Re: Draft Plan of Subdivision and Zoning By-law Amendment Applications  
173146 County Road 25; Part of Lot 30, Concession 2  
Town of Grand Valley, County of Dufferin

The following section represents our response to comments received from R.J. Burnside (January 2019):

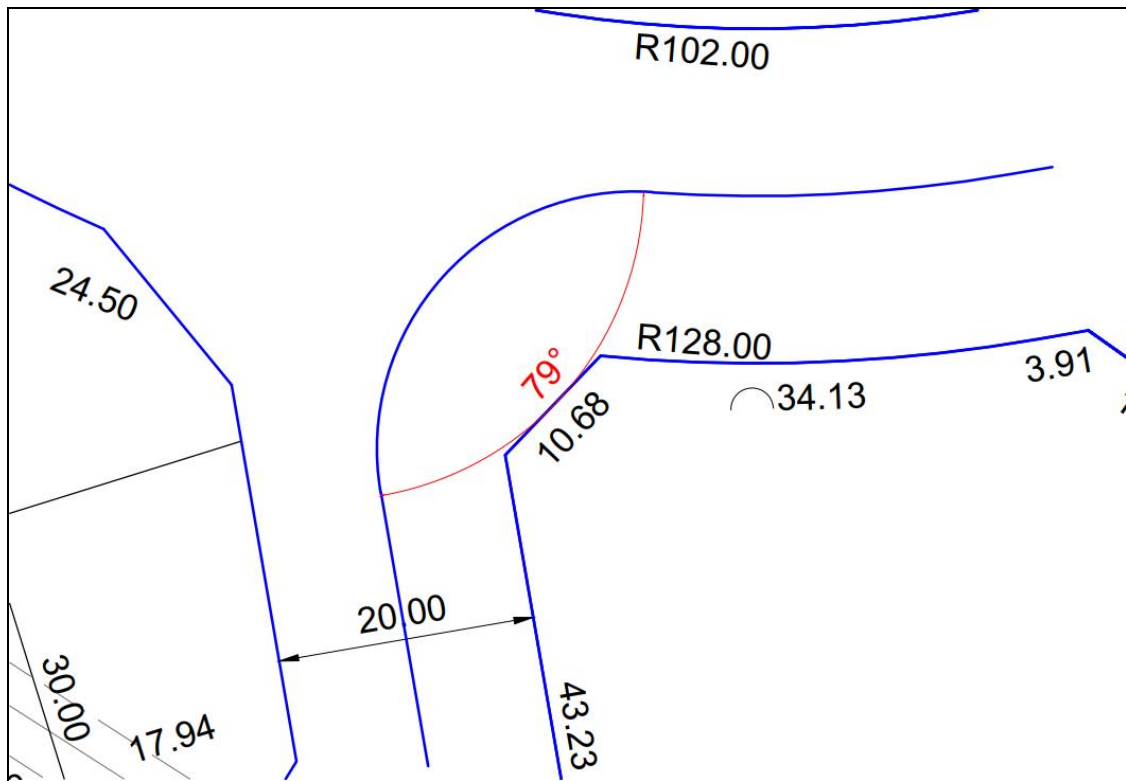
**Comment #1:**

As a result of discussions and agreed upon direction at a stakeholder meeting (attended by Thomasfield Homes, Corseed Inc, GRCA, and the Town of Grand Valley), held at the Town of Grand Valley on February 14, 2019 the collector road bisecting the Corseed project has been realigned such that it:

- Avoids traversing the existing privately-owned residential property located at 173160 County Road 25 (CR-25)
- Provides adequate separation to the adjacent property at 173160 County Road 25 to allow for grading
- Provides a 30.0 metre setback from the collector road to the wetland positioned west of it
